Item No.
5

CITY OF WESTMINSTER		
PLANNING APPLICATIONS SUB COMMITTEE	Date 9 June 2020	Classification For General Release
Report of Director of Place Shaping and Town Planning		Ward(s) involved St James's
Subject of Report	Flat 17, Vale Royal House, 36 Newport Court, London, WC2H 7PS	
Proposal	Erection of a single storey roof extension and alterations to existing roof slope at first floor level including the creation of a terrace.	
Agent	Savills	
On behalf of	Mr Shelford	
Registered Number	20/00355/FULL	Date amended/completed
Date Application Received	20 January 2020	21 January 2020
Historic Building Grade	Unlisted	
Conservation Area	Chinatown

Existing and proposed roof plans

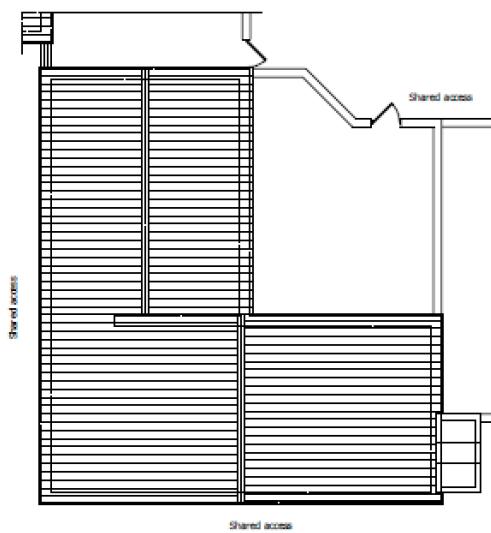
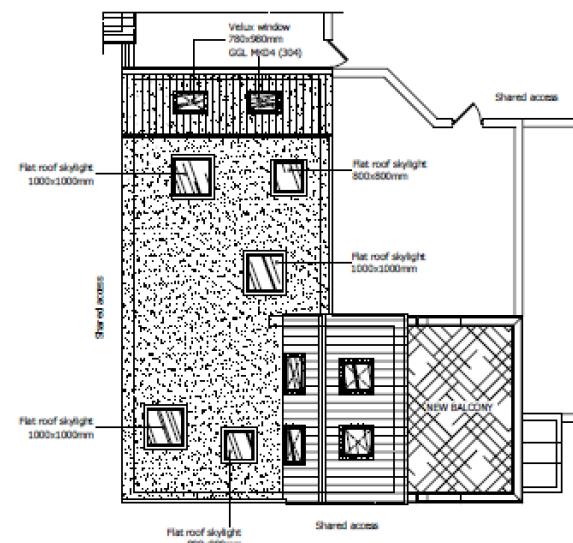
It is considered that the bulky flat-topped extension to Flat 17 does not draw from this context or relate sensitively to it, but that features in the perimeter larger-scale buildings are being used to justify some of the features that are being introduced. It is considered that the character and appearance of the local area of the estate would be greatly diminished by the alterations proposed to Flat 17 and that these alterations would also result in harm to the visual amenity of the conservation area. As there are no public benefits of the scheme to outweigh this less than substantial harm, the proposal would not accord with Paragraph 196 in the NPPF (2019), Policies S25 and S28 of Westminster's City Plan (adopted in 2016), Policies DES 1, DES 5, DES 6 and DES 9 of the Council's Unitary Development Plan (adopted in 2007) and the conservation area audit. Therefore, the recommendation to refuse permission on design grounds is compliant with the requirements of the NPPF and the statutory duties of the Planning (Listed Buildings and Conservation Areas) Act 1990.

The proposed works would result in an increased massing to the main roof profile; namely, a large proportion of the roof would be increased by approximately 0.9m in

Objections have been received with regards to the impact of glare from the proposed new rooflights on neighbouring occupiers. The rooflights facing Flats 18 and 19-28 Vale Royal House would be of a distance that is not considered to result in any glare to the detriment of these neighbours. All other rooflights would be either facing upwards or towards the Podium, as to not result in any harmful glare to neighbouring residents. The comments are therefore not sustained.

Proposed elevations

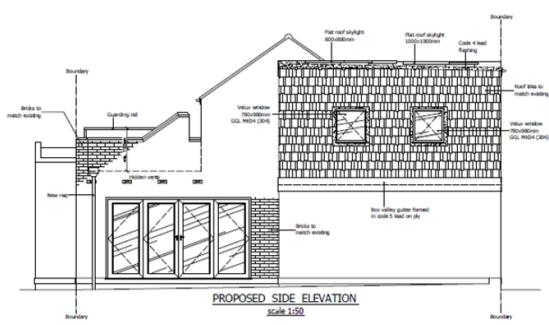
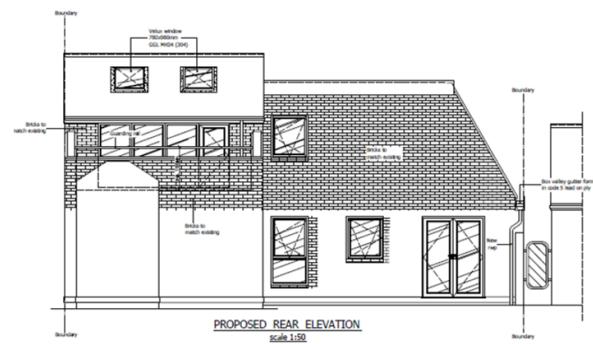
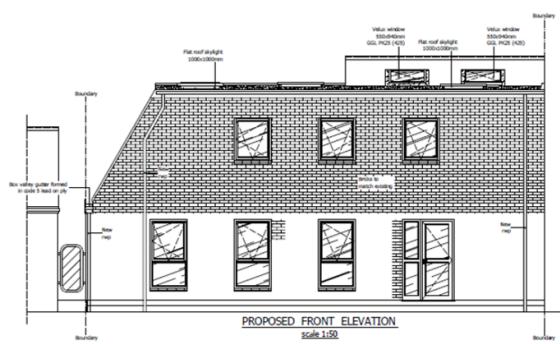
The proposed elevations show the installation of two new Velux windows at first floor level to the eastern elevation (serving a utility room), and one new window at first floor level to the western elevation (serving the newly created stairway). Due to the close proximity between the host and adjacent neighbouring properties, it is considered that the east-facing windows may result in unnecessary undue overlooking into the habitable rooms and private garden spaces of the adjacent neighbouring properties (namely flat nos. 18 and 19 Vale Royal House). Had the proposals been considered acceptable, a condition would have been recommended requiring these windows to be obscured glazed and fixed shut or with limited opening.

Due to the siting of the new west-facing window on the first floor, in conjunction with the angle and distance from the private garden of flat no. 16 Vale Royal House, this window is not considered to result in an undue amount of overlooking and loss of privacy. The proposed fenestration changes to the north and south of the property are also not considered to raise any issues in this regard given their outlook onto a boundary wall to the north and onto the Podium to the south.

The proposed terrace would be bounded by a 0.8m tall brick wall with a guard rail (consisting of one continuous metal bar) measuring 1.1m high from terrace floor level around the perimeter. No screening is proposed. By virtue of the design, siting and close proximity to adjacent neighbouring flats, notwithstanding the provision of the brick wall, it is considered that direct undue overlooking would still be achievable into the private garden of Flat 16 Vale Royal House and would provide the possibility for overlooking into the habitable rooms of Flats 15 and 16 and the private garden of Flat 19. This would be contrary to Policies ENV 13 of the UDP and S29 of the City Plan and is therefore unacceptable on amenity grounds.
